First beat: instrument identity and complete sequencer

ACTUAL3c41 ELITE EMULATOR

R6 PROPOSAL / NOT FIRMWARE

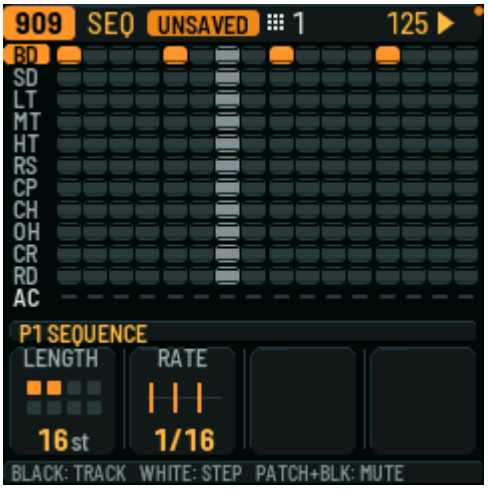
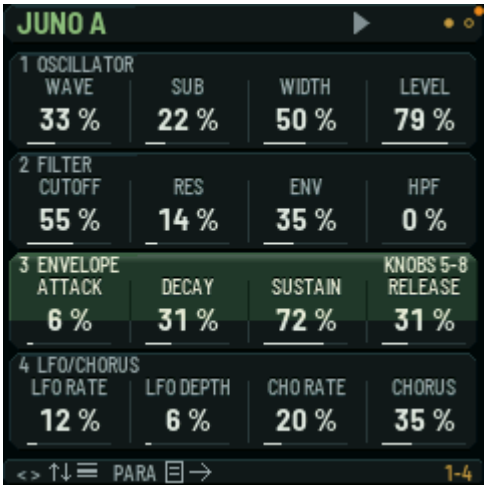
Change / reconsider Recognizable instrument pictures plus common compact status; all useful lower controls stay.

Tradeoff / unknown Running phase and unspecified project cells are not synchronized. Picture recognition and audible outcome are not qualified; this is a visual/model proposal.

Juno: preserve large values and fast parameter editing

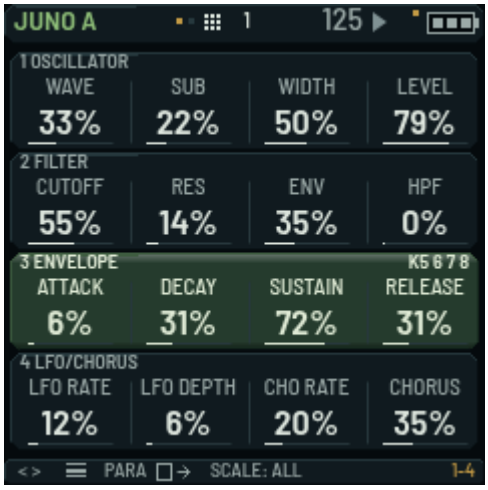
Change / reconsider R5 contrast loss is corrected; unproven heading thumbnails are withdrawn. Native large bright values/neutral bars stay. Contextual held/motion scope uses only the selected-row gutter.

Tradeoff / unknown Actual complete3c41 ENVELOPE is paired with the same proposed selected row and same values. The selected-row lock/motion gutter cue is an extension whose usefulness/recognition still requires assessment. The earlier oscillator capture has an incomplete lower band and is excluded from equivalent-state presentation. No AudioKitJ6, audio or live-cursor fidelity claim.

Miami: keep its actual native vocabulary

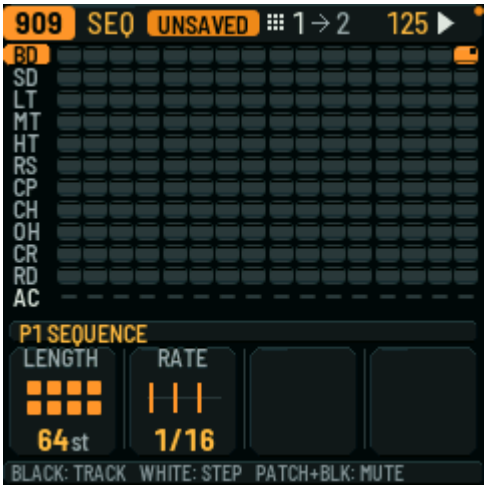
Change / reconsider Only the common top status/power composition changes. No replacement Juno/ADSR-style language is introduced into Miami.

Tradeoff / unknown After is explicitly a static native-body composition. Interactive authored known-q fixture uses source edited text/wave lookup and is separate: untouched nativeTUNE+0.91 is not reachable at editedq75(+0.87) or76(+0.95). Hidden native/factory fields are not exported. No audio/backend/other-factory parity claimed.

Correct64steps while a pattern is pending

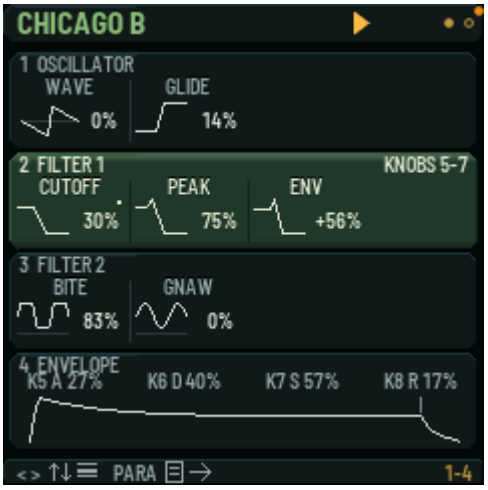
Change / reconsider Absolute49-64/64 stays in the otherwise unmapped lower half when the native pending badge replaces the header range. A held nondefault chance uses that same area.

Tradeoff / unknown Actualv3 verifies STEP64:95% andP1 to P2. Running phase is unsynchronized; no exact probability/audio timing result. Selected instrument illustration uses only formerly unmapped K7/K8 space.

Write a bar, select it, change one part

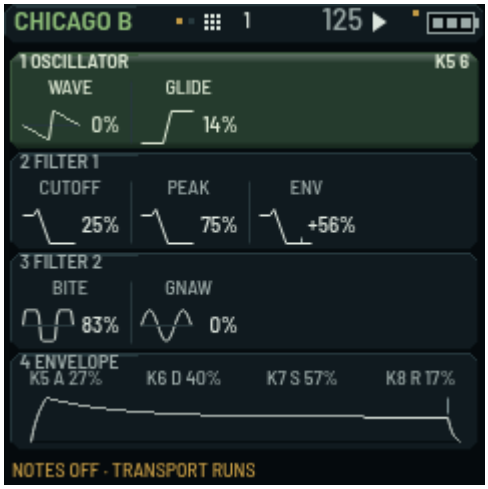
Change / reconsider R5 model defect is corrected: pad writes all fiveP1 assignments and selects BAR2/END; K5 and both BAR pages now edit real data.

Tradeoff / unknown Manual bar authoring is separate from future capture strategy. Arrangement audio/recording/durable reload are not accepted by this model. Song at192bars has no extra END row.
